From: Justin Wortman <jwortman@oakpointe.com>
Sent: Monday, March 1, 2021 3:25 PM
To: Mona Davis
Subject: Black Diamond Comprehensive Plan Amendment -- Items for Docket
Attachments: BD Comprehensive Plan Amendment - SEPA Checklist.pdf; Comp Plan Amendment - SE Loop Connector Alternative.pdf; Master Permit Application_signed.pdf; Sensitive Area ID Form_signed.pdf; Comprehensive Plan Submittal.pdf

RE: City of Black Diamond Comprehensive Plan Amendment – Items for Docket

Date:	March 1, 2021	TG:	16450.00
To:	Andrew Williamson – City of Black Diamond		
From:	Mike Swenson, P.E., PTOE and Maris Fry, P.E. – Transpo Group		
cc:	Brian Ross and Justin Wortman – Oakpointe		
Subject:	Comprehensive Plan Amendment – SE Loop Connector Alternative

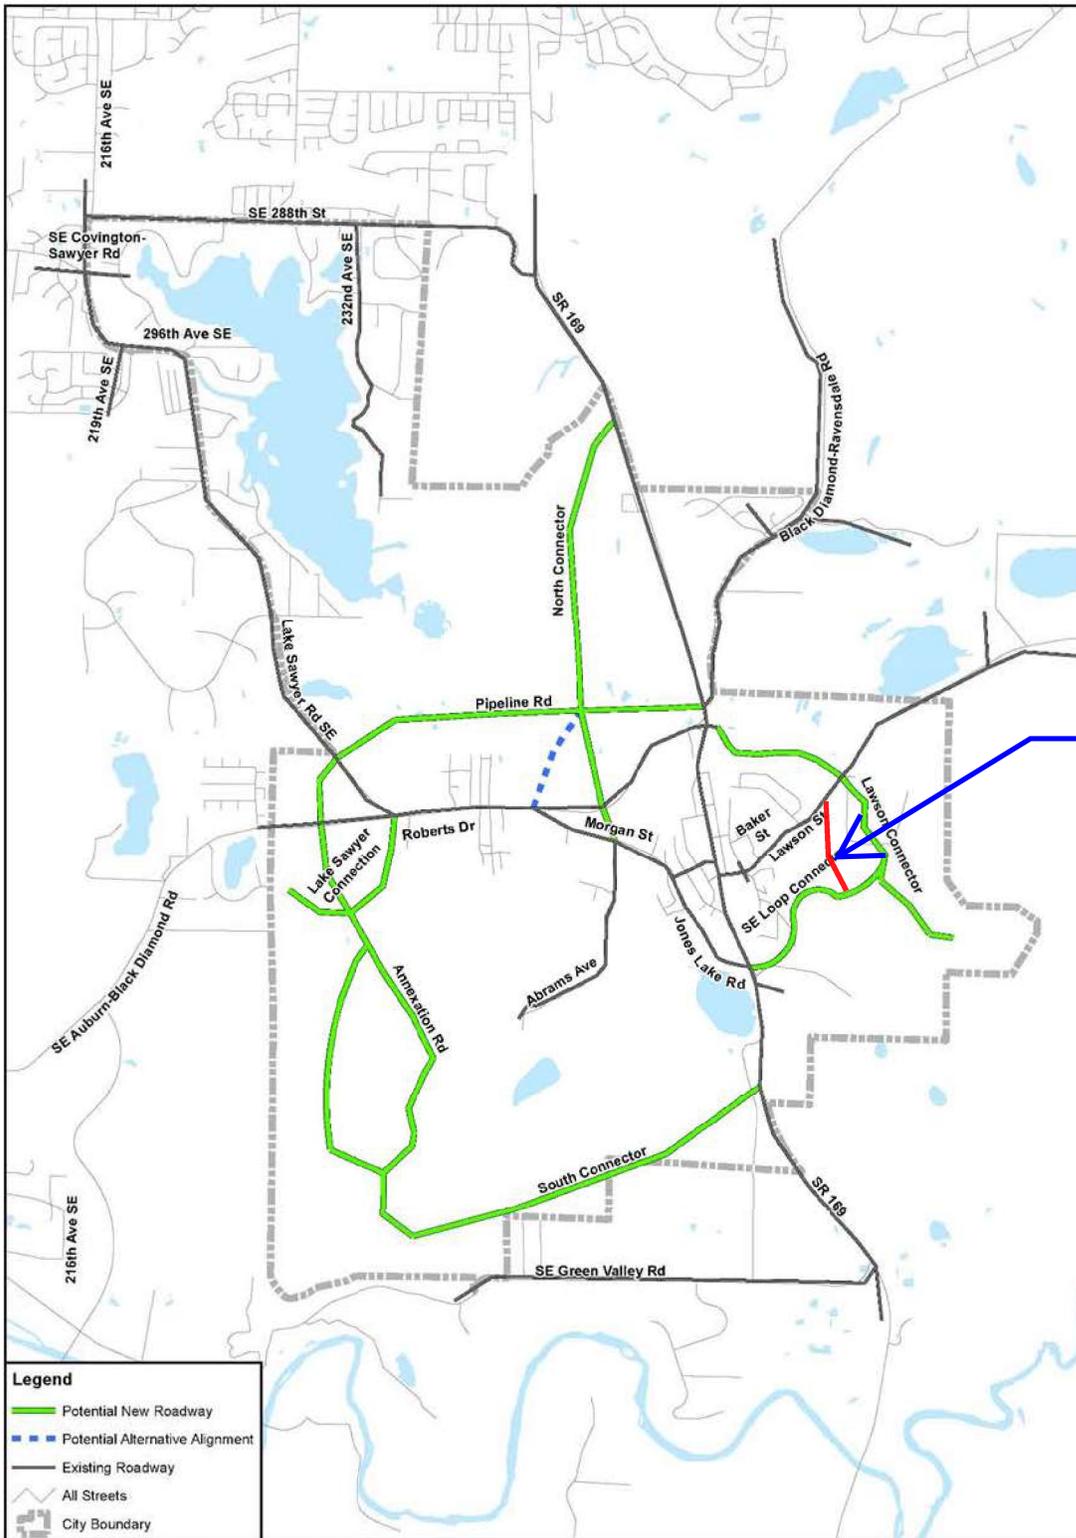
A conceptual configuration for the future roadway system in 2035 is shown in Figure 7-4. New arterial and collector roads include: Pipeline Road, Annexation Road, Lake Sawyer Extension, Lawson Connector, South Connector, Southeast Loop Connector or Southeast Loop Connector Alternative, and North Connector.

- Functional Classification System - Comp Plan Text Change 1
- Transportation Improvement Recommendations - Comp Plan Text Change 2
- Table 0.9 - Comp Plan Text Change 3
- Figure 7-4 - Comp Plan Map Change 1.

Figure 1: Proposed SE Loop Connector Alternative (Base Map Source: City of Black Diamond 2019 Comprehensive Plan)

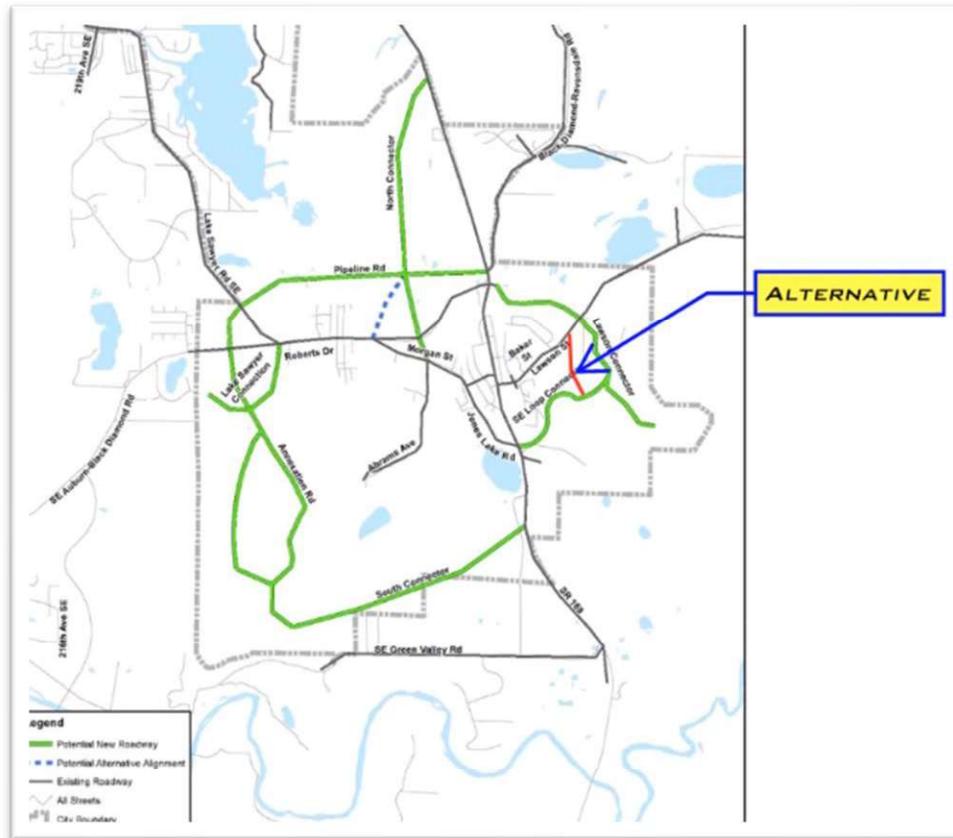
As shown in Figure 1, the Comprehensive Plan currently identifies the SE Loop Connector as a connection between the Lawson Connector and SR 169. The identified SE Loop Connector Alternative is shown in Figure 1.

To determine the worst-case impacts of the SE Loop Connector Alternative, traffic volume projections from the Lawson Hills TTR were revised to account for re-routed traffic. This analysis conservatively assumed that all traffic routed through the SE Loop Connector in the EIS is re-routed to Lawson Street. Figure 1 depicts the re-routed volumes and the adjusted full-build traffic volumes.

In order to meet WSDOT's LOS D or better standard, additional southbound and eastbound right-turn lanes would be needed at SR 169/Baker Street and an additional westbound right-turn lane would be needed at SR 169/Lawson Street. Additionally, the traffic signal and northbound left-turn lane would need to remain at the intersection of SR 169/Jones Lake Road. Consistent with the EIS, no mitigations would be necessary at the intersection of Railroad Avenue/Baker Street. The mitigated channelization and traffic control assumptions are summarized in Figure 1. With these additional mitigations in place, the intersections are projected to operate at LOS D or better, as shown on Table 1.

Figure 1: Proposed SE Loop Connector Alternative (Base Map Source: City of Black Diamond 2019 Comprehensive Plan)

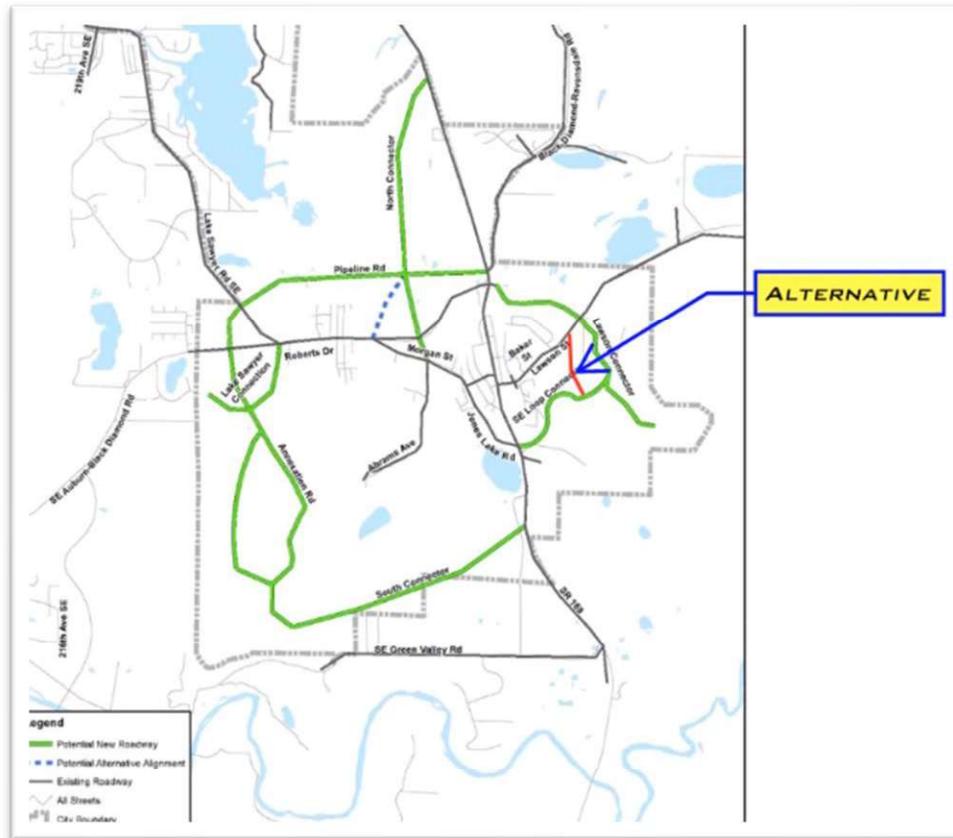
As shown in Figure 1, the Comprehensive Plan currently identifies the SE Loop Connector as a connection between the Lawson Connector and SR 169. The identified SE Loop Connector Alternative is shown in Figure 1.

To determine the worst-case impacts of the SE Loop Connector Alternative, traffic volume projections from the Lawson Hills TTR were revised to account for re-routed traffic. This analysis conservatively assumed that all traffic routed through the SE Loop Connector in the EIS is re-routed to Lawson Street. Figure 1 depicts the re-routed volumes and the adjusted full-build traffic volumes.

In order to meet WSDOT's LOS D or better standard, additional southbound and eastbound right-turn lanes would be needed at SR 169/Baker Street and an additional westbound right-turn lane would be needed at SR 169/Lawson Street. Additionally, the traffic signal and northbound left-turn lane would need to remain at the intersection of SR 169/Jones Lake Road. Consistent with the EIS, no mitigations would be necessary at the intersection of Railroad Avenue/Baker Street. The mitigated channelization and traffic control assumptions are summarized in Figure 1. With these additional mitigations in place, the intersections are projected to operate at LOS D or better, as shown on Table 1.
